E8364CH85-02

S E R V I C E N O T E

E8364CH85 PNA Microwave Network Analyzers

A new touchscreen display inverter shield is available to improve PNA noise floor performance.

Figure 3

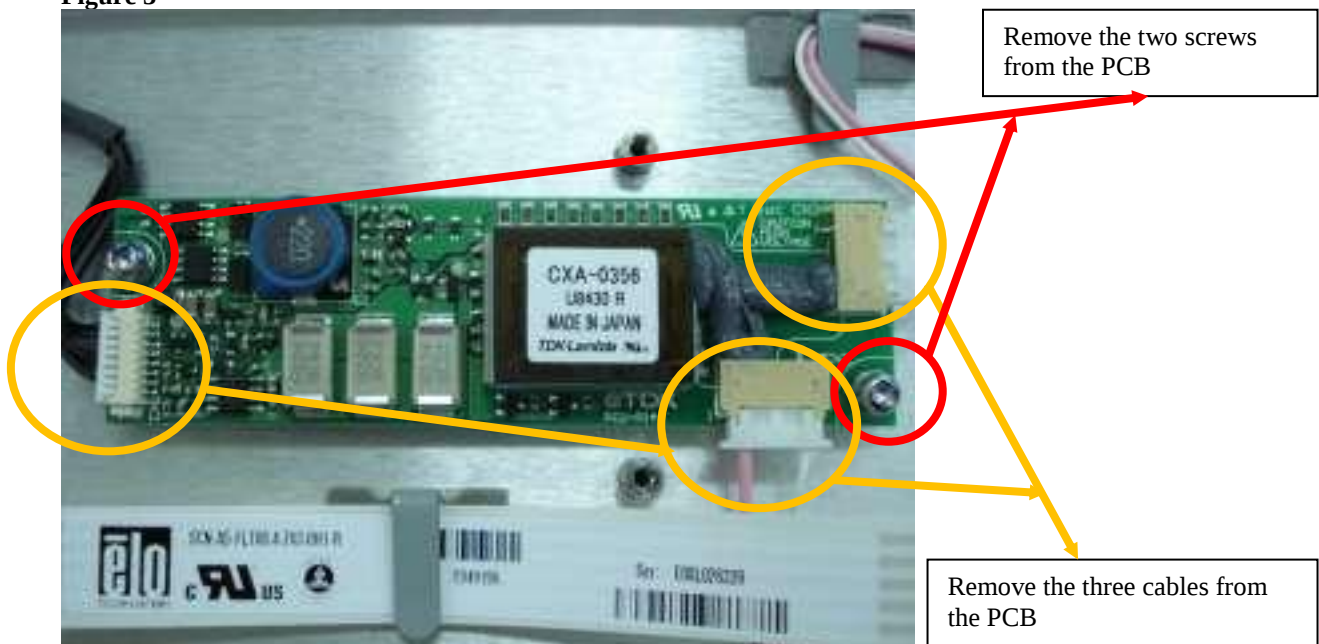
10. Remove the two screws from the PCB shown in Figure 3, using a T-10 wrench.
Disconnect the three cables connected to the PCB.
